Action Memorandum for the Time Critical Removal Action (TCRA) under CERCLA for the "Washrack" and "Farm Fuel" Sites and Action Memorandum for the Non-Time Critical Removal Action under CERCLA for the "Wood Dump" Site
Former United States Disciplinary Barracks, Lompoc, California.

**“ACTION MEMORANDUM”
FOR THE
NON-TIME CRITICAL REMOVAL ACTION
UNDER CERCLA FOR THE
“WOOD DUMP” SITE**

Comments and Response to Comments on Draft Action Memorandum and Final Draft Action
Memorandum for the Wood Dump Site

SITE PLAN
FINAL ACTION MEMORANDUM, WOOD DUMP SITE
Former United States Disciplinary Barracks
Lompoc, California

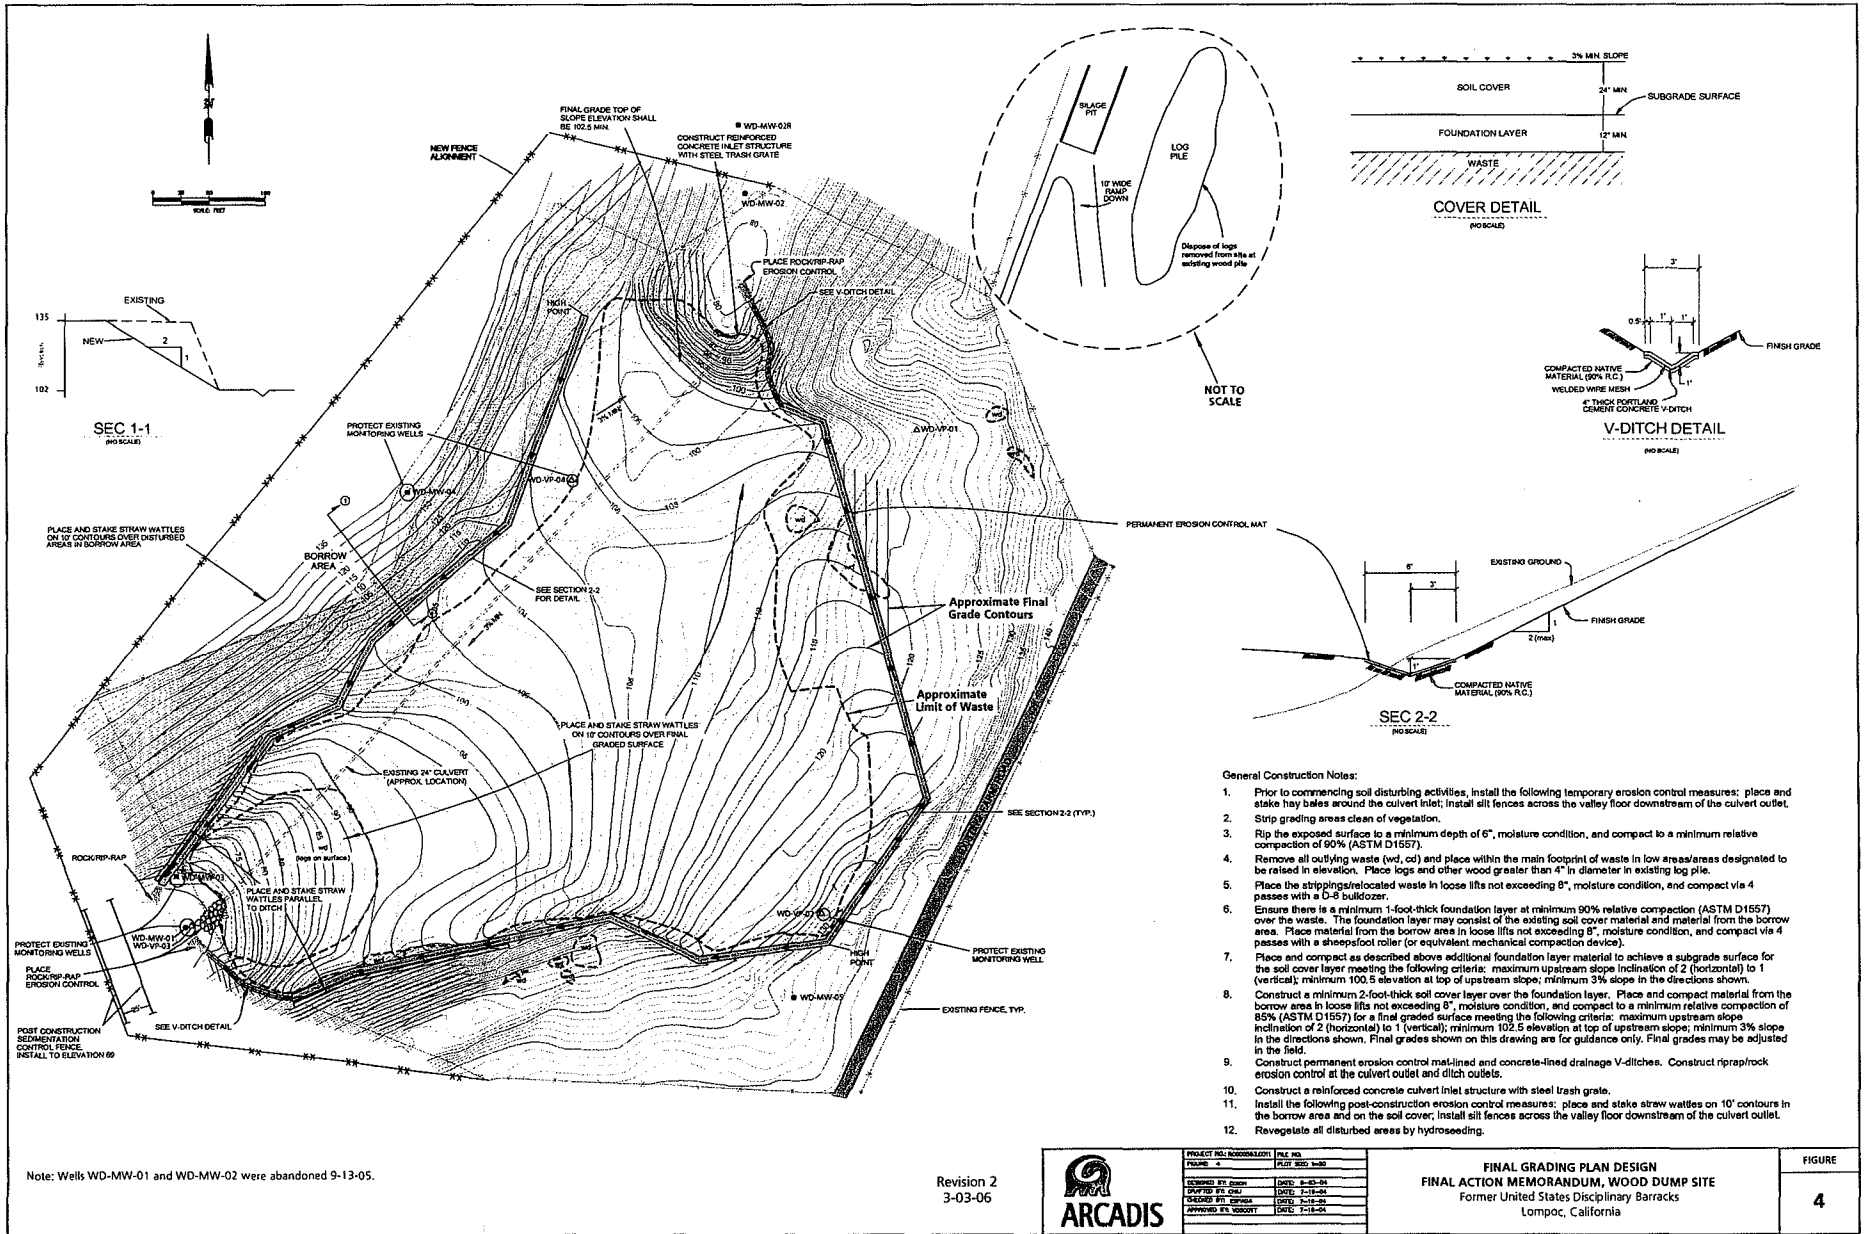
19	Figure 3	Note that the culvert location is approximate, and that the log pile/silage areas are not to scale, or scale approximate.	Comments incorporated.
20	Figure 4	Replace this figure with the revised grading plan. Also note that this figure does not show the few outliers of waste material on the northeast side of the Wood Dump.	Comments incorporated. The figure has been modified to indicate the approved general final grading design elements.
